TISDALE WEIR REHABILITATION AND FISH PASSAGE PROJECT

Final Environmental Impact Report

Prepared for
California Department of Water Resources

August 2021

Figure 19
TUFLOW Model – Change in Average Depth by Parcel (Dry Days)
Tisdale and Sutter Bypass (Wet WYs), Project Conditions

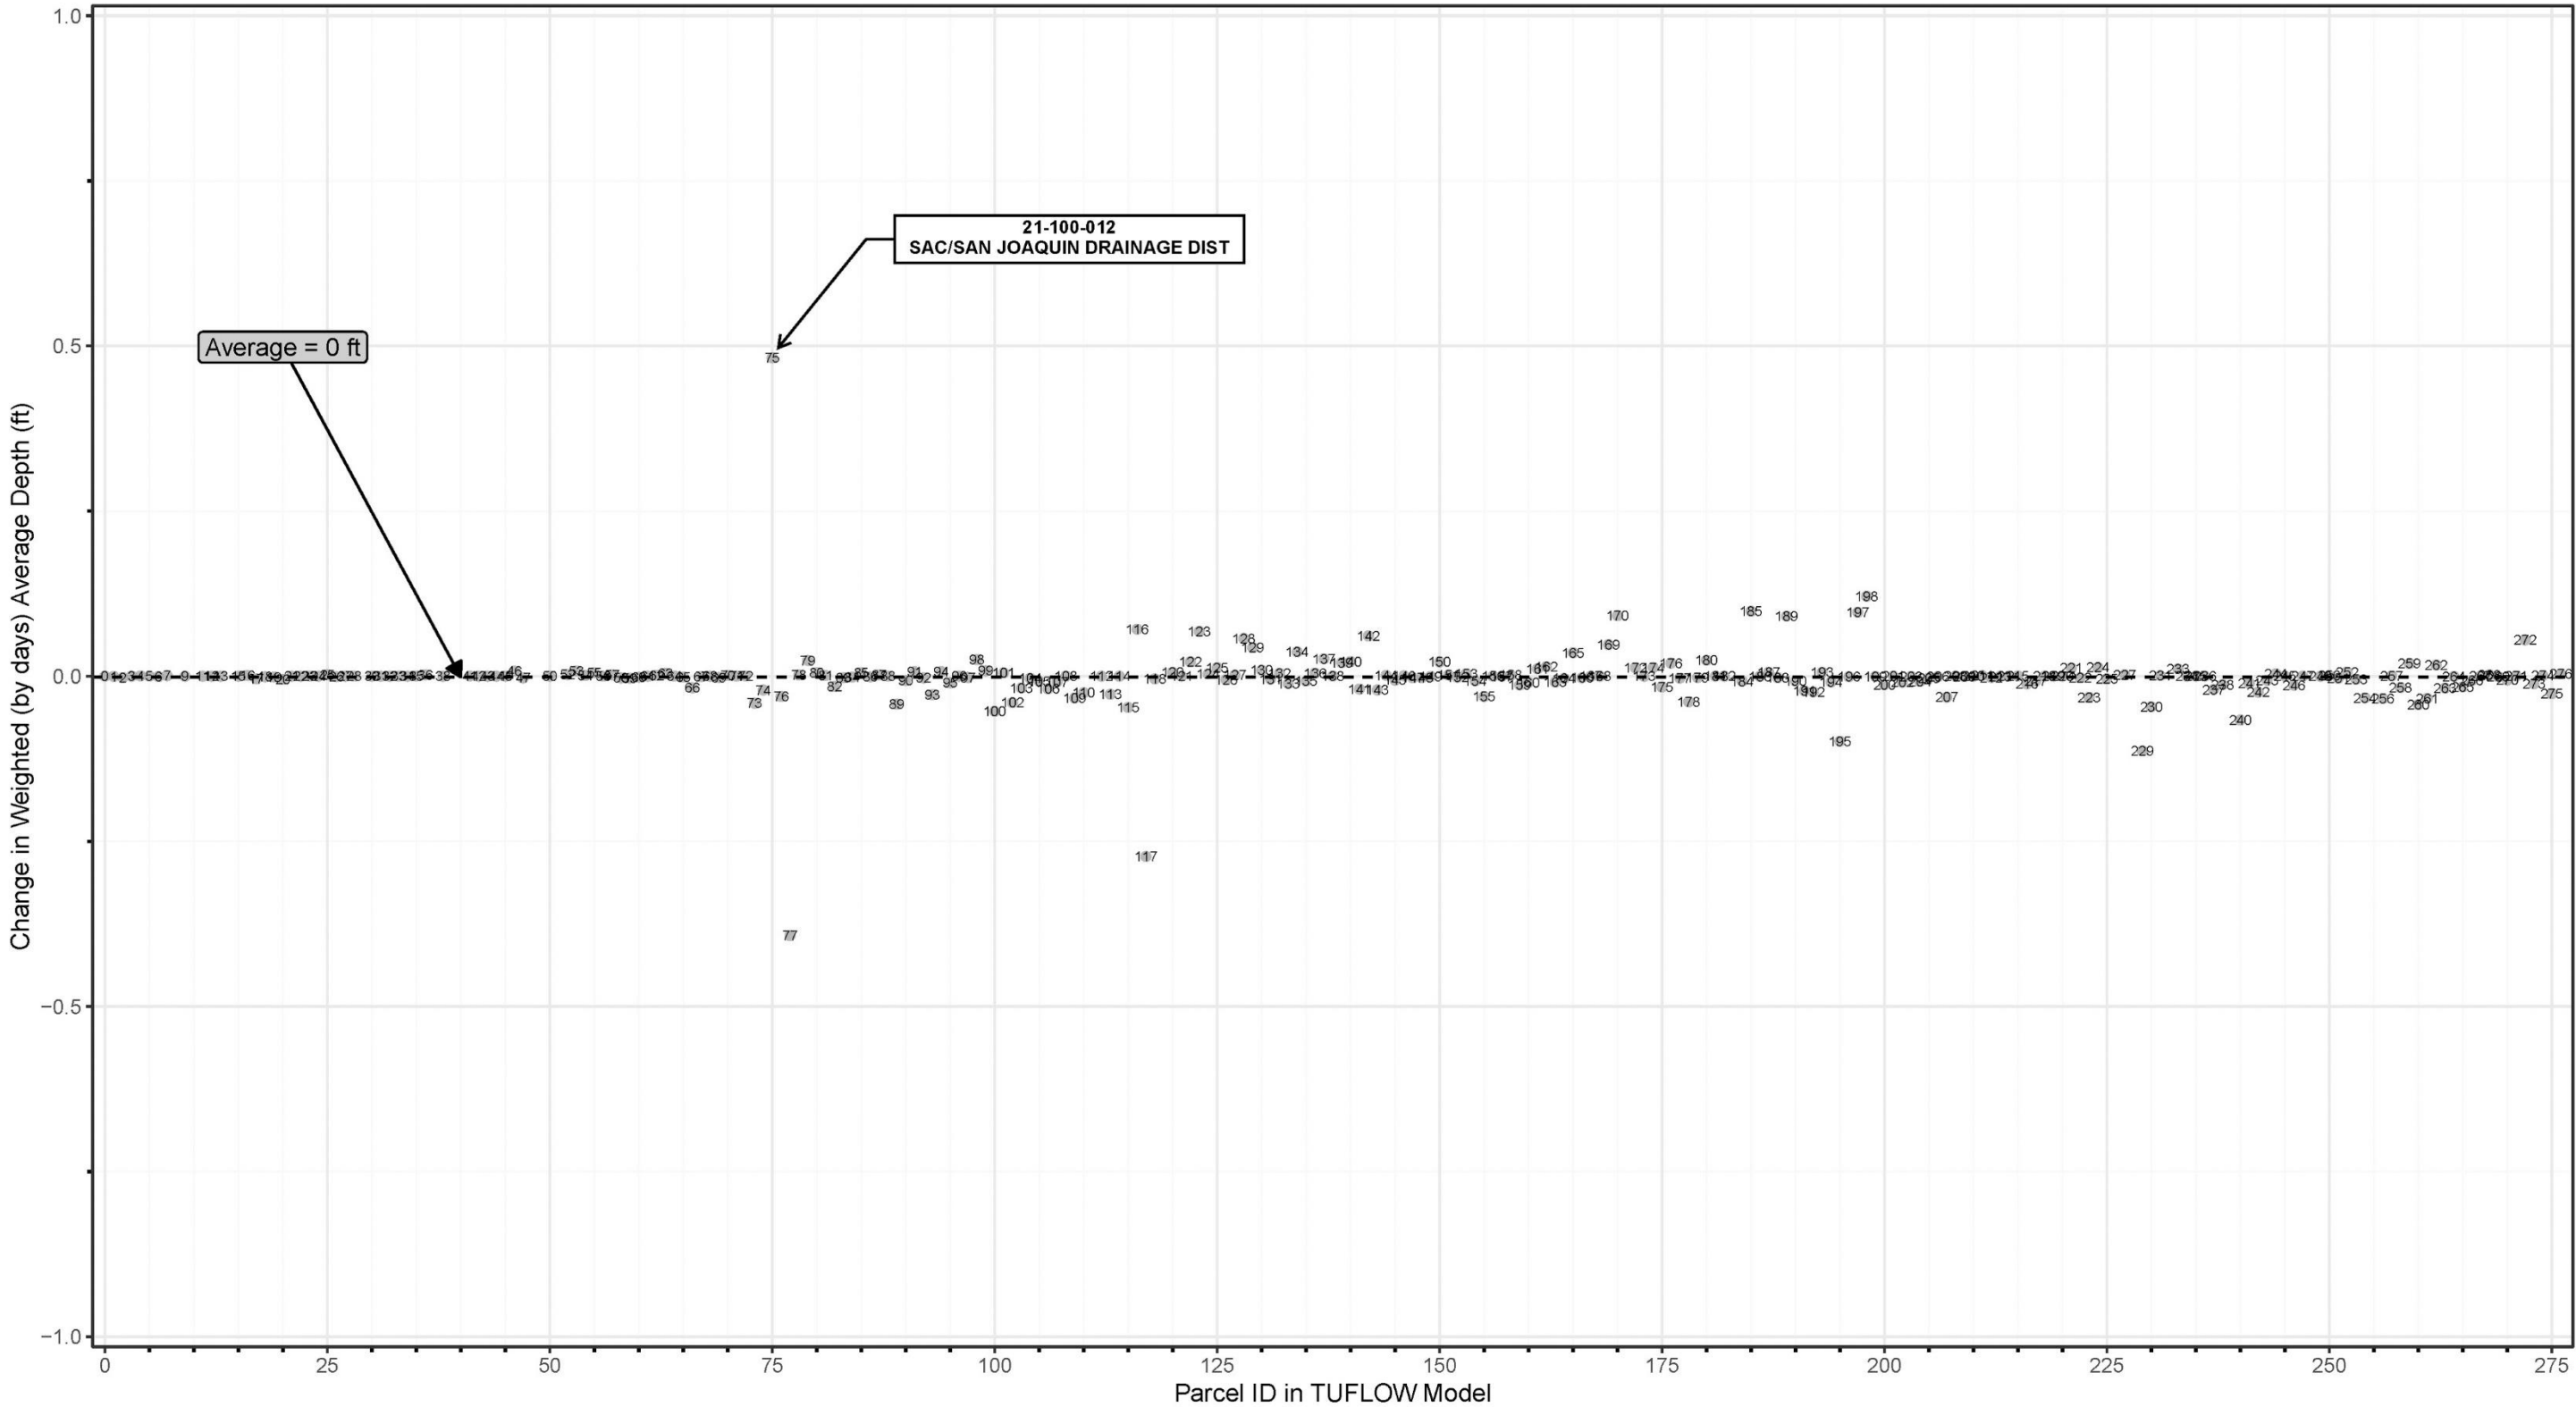
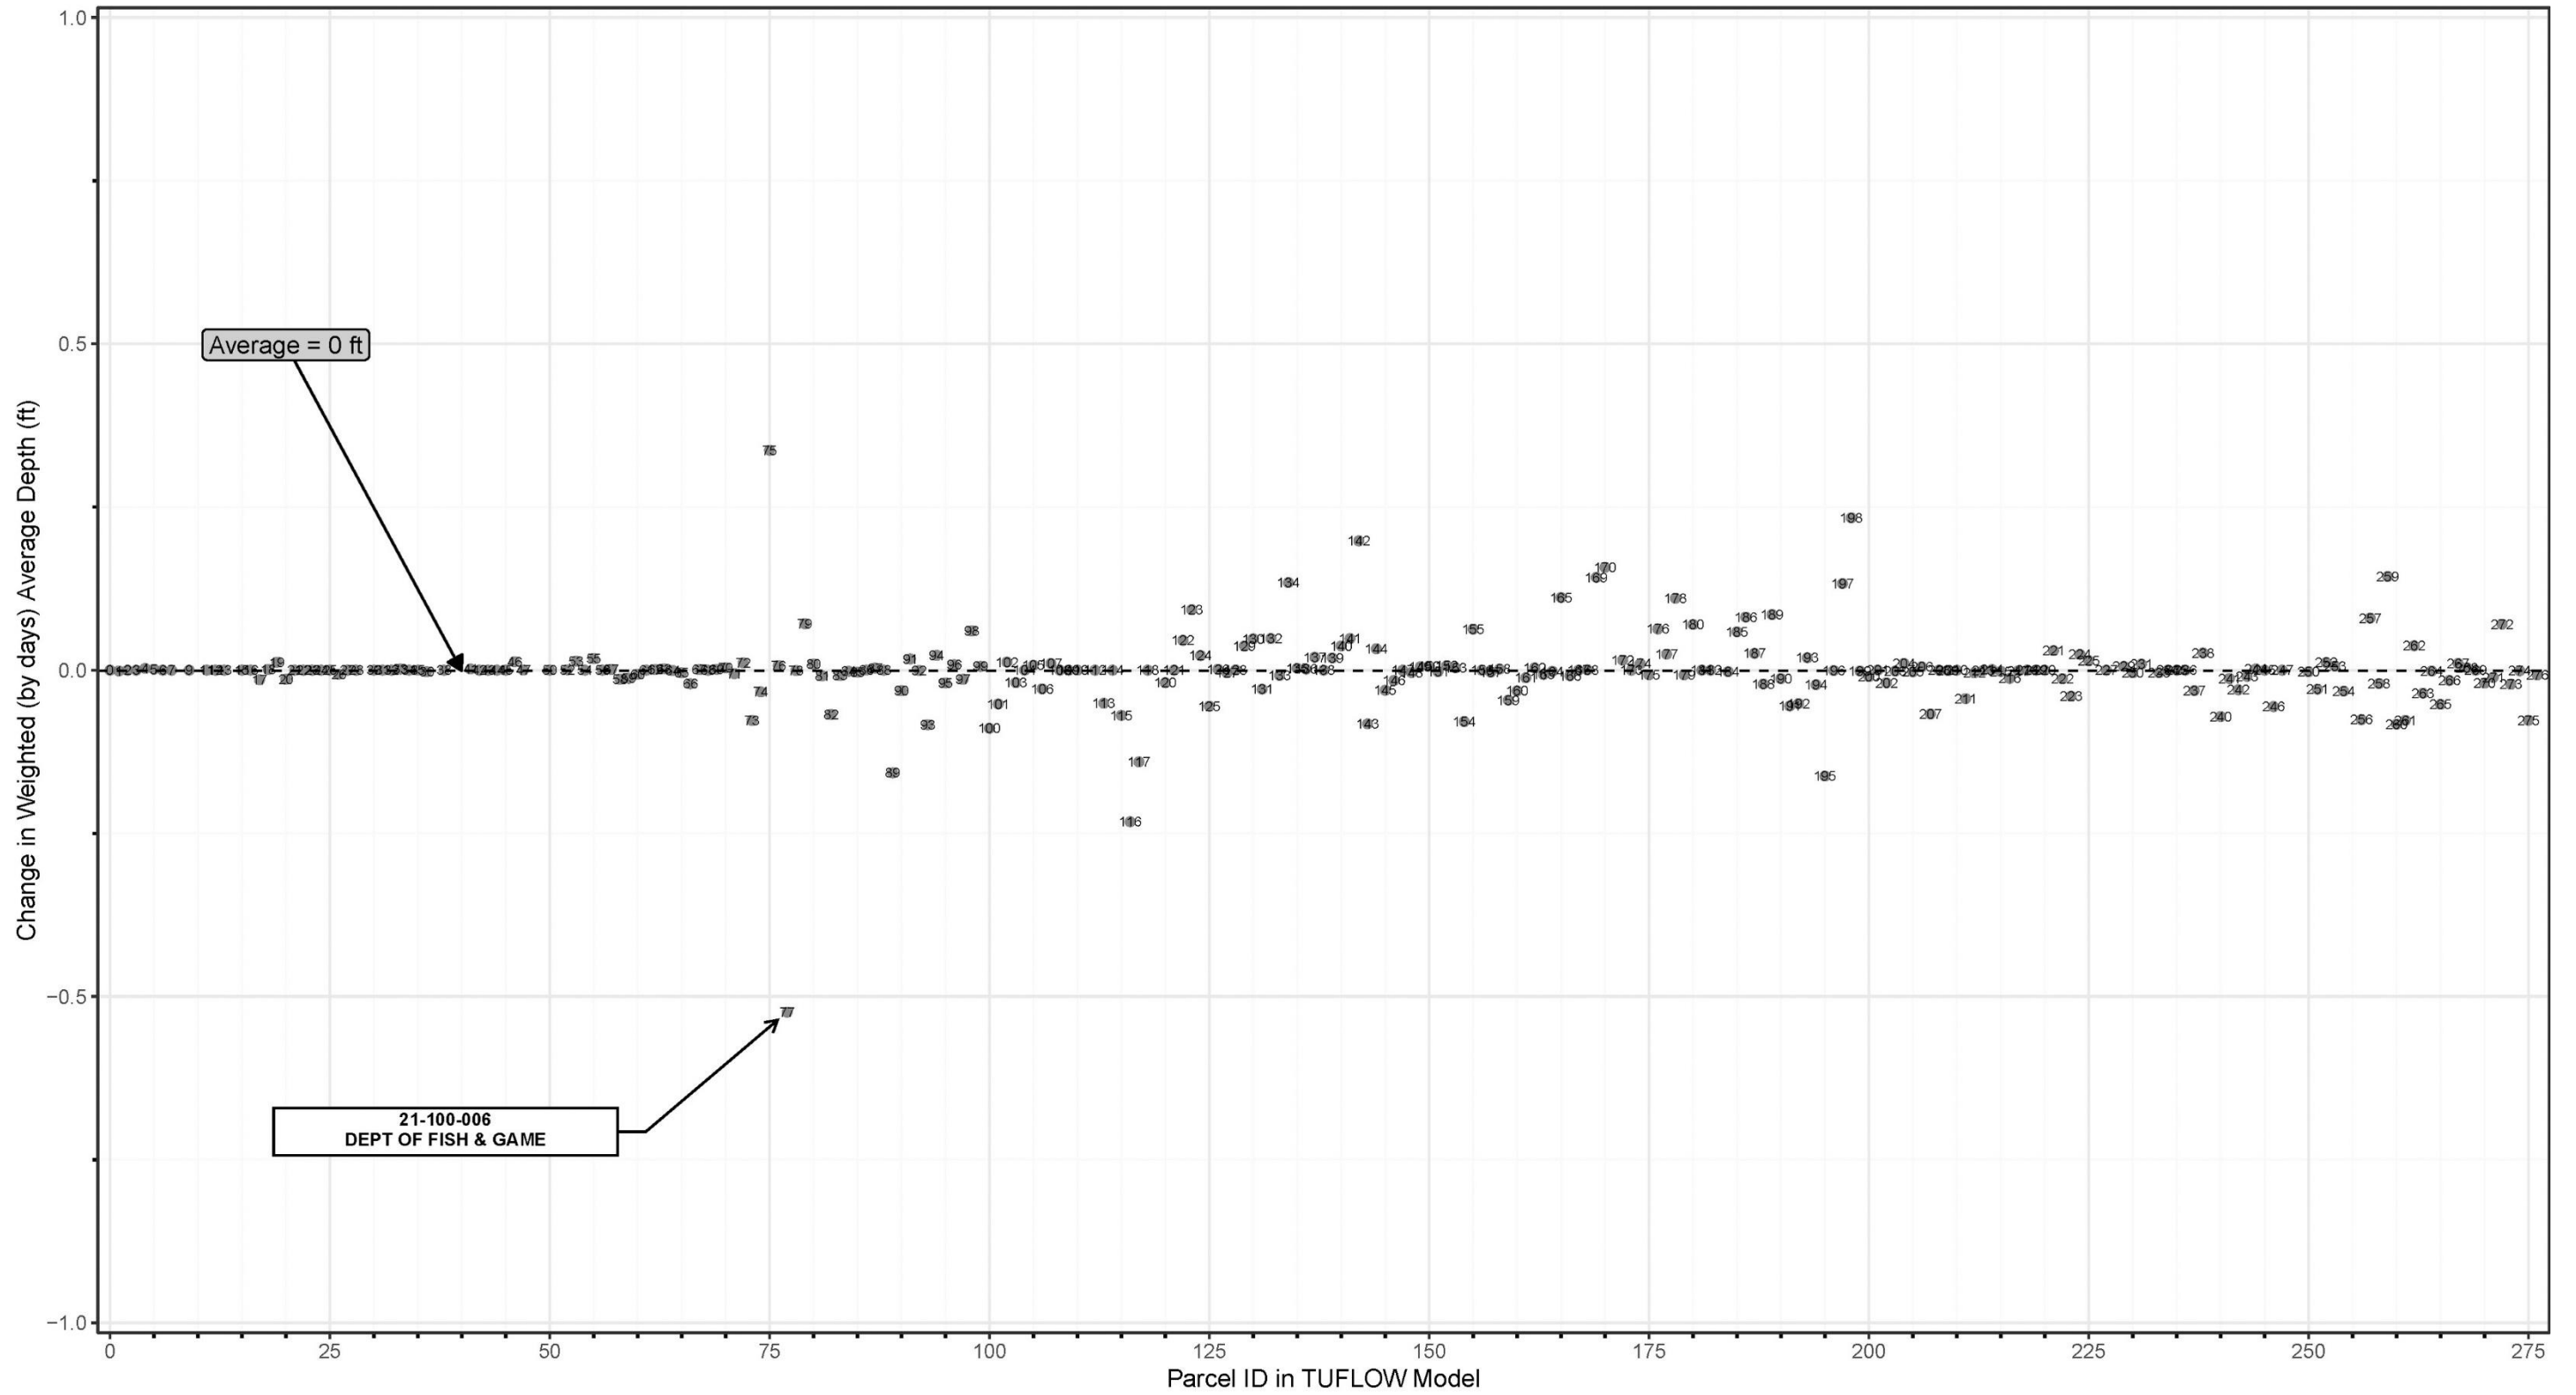
Figures 13 through 24 in Attachment E of this FEIR present the average changes in water depth, by water year type, for each parcel in the Sutter Bypass and, as shown, the predicted changes in water depth are very minor. As evident in Figures 13 through 24, the predicted increases in depth for wet days and dry days that are greater than approximately 0.5 feet are for parcels that belong to the Sacramento/San Joaquin Drainage District or the California Department of Fish and Wildlife (CDFW). In addition, Attachment F of this FEIR provides the change in the number of wet days for the waterfowl season for all water years and parcels in the Sutter Bypass.
